## LINCOLN PARK PLANNING COMMISSION

3719 Fort – Office

## Site Plan Review

Applicant	Mariam Rushin
Project	Office
Address	3719 Fort Street, Lincoln Park, MI 48146
Date	April 13, 2022
Request	Site Plan Review

**SITE PLAN PARKING** SCALE: 1" = 10'-0"

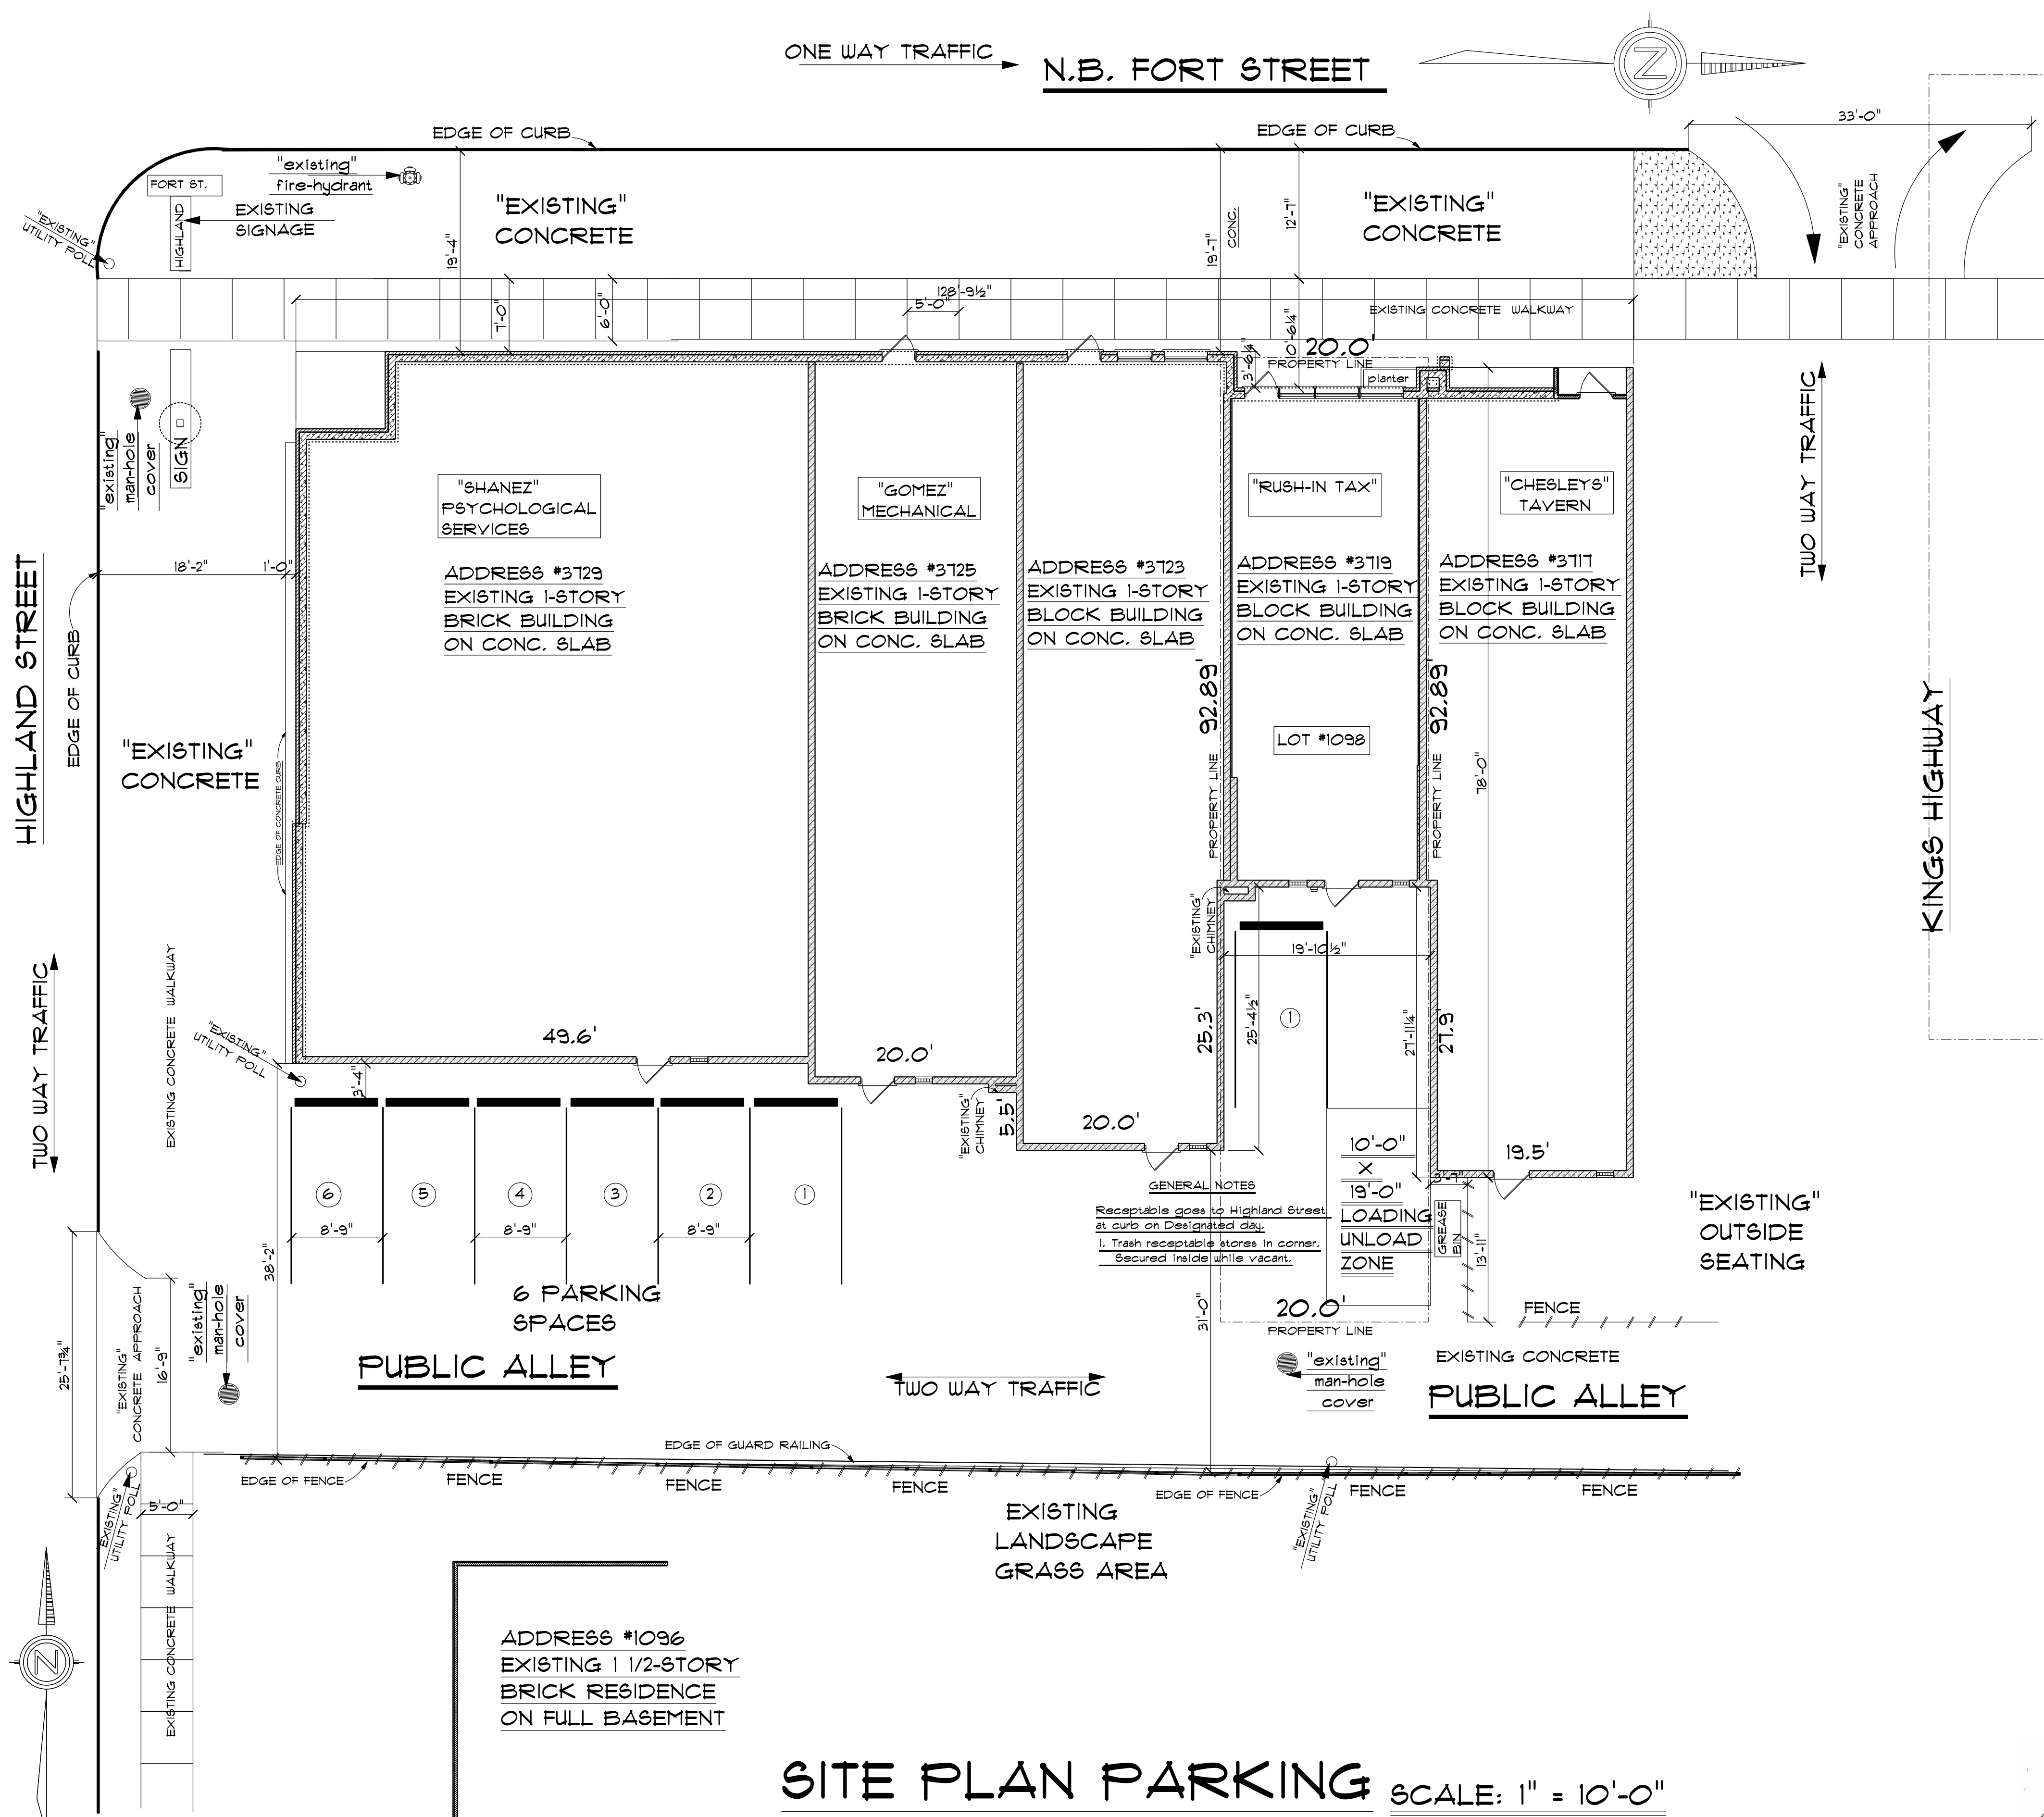
The proposed number of the parking spaces does not comply with the parking requirements for the proposed use, and the small size of the site prevents the applicant from providing the required four parking spaces. However, there is public on-street parking available along Fort Street. There is ample room in the back to fit two parking spaces; however, the site plan only shows one space with a loading space. A loading space is not required due to the size of the building; therefore, the loading space may be removed to allow for an additional parking space. Given the extremely limited ability of the site to accommodate parking, it is the Planning Commission’s responsibility to determine whether the proposed parking plan offers adequate provision for the intended use while preserving the public health, safety, and welfare.

- A Planning Commission waiver is requested to reduce the number of parking spaces from 4 to 2. Considerations include the size and configuration of the existing site.
- Applicant shall remove the loading area and add a second parking space to the rear parking area.

- Applicant shall remove the loading area and add a second parking space to the rear parking area.

FRONT-WEST ELEVATION  
 REAR-EAST ELEVATION

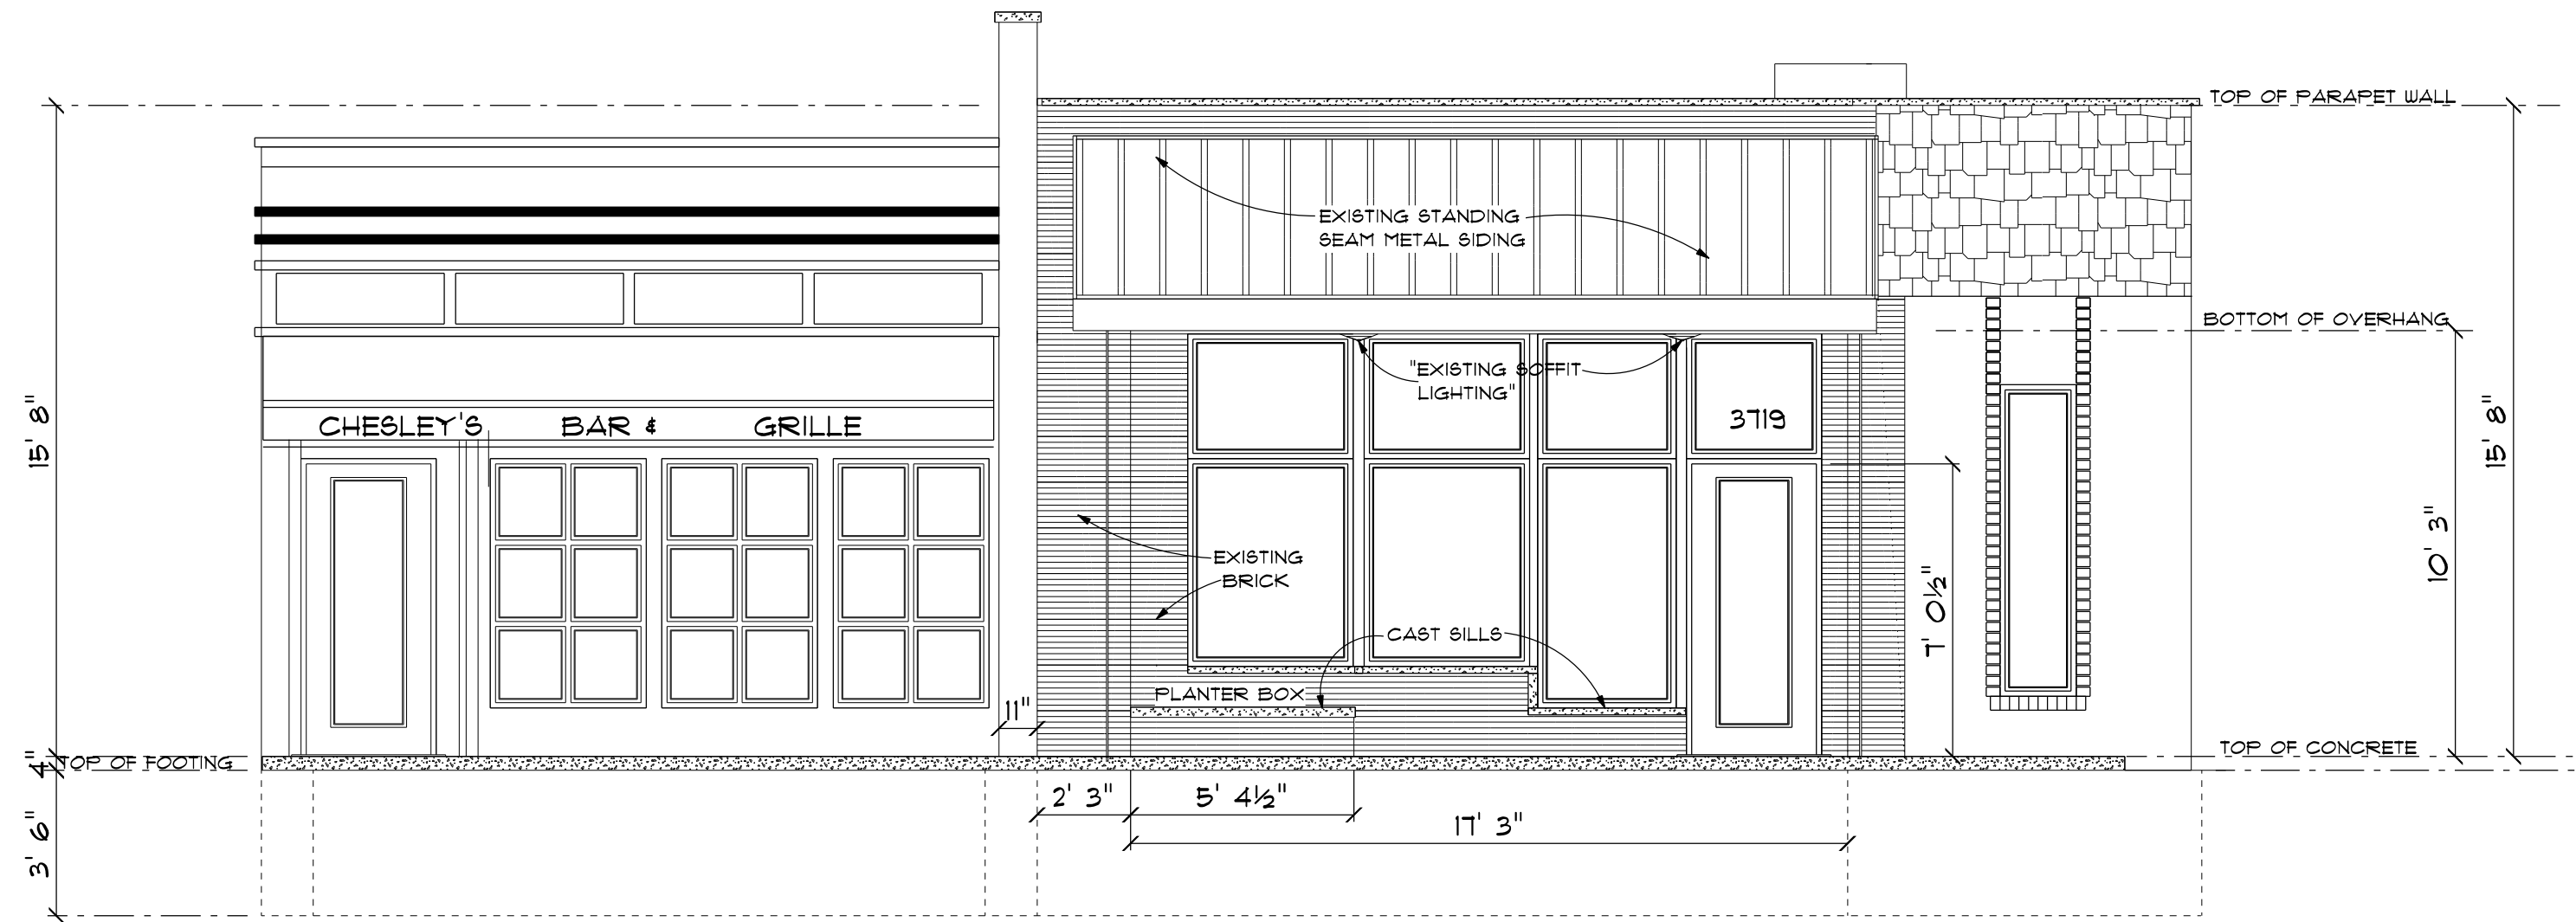
This is an existing building that meets all requirements excluding the building material requirement on the front elevation. The proposal does not include any changes to the existing facades; therefore, the City has historically permitted existing façade conditions to remain.
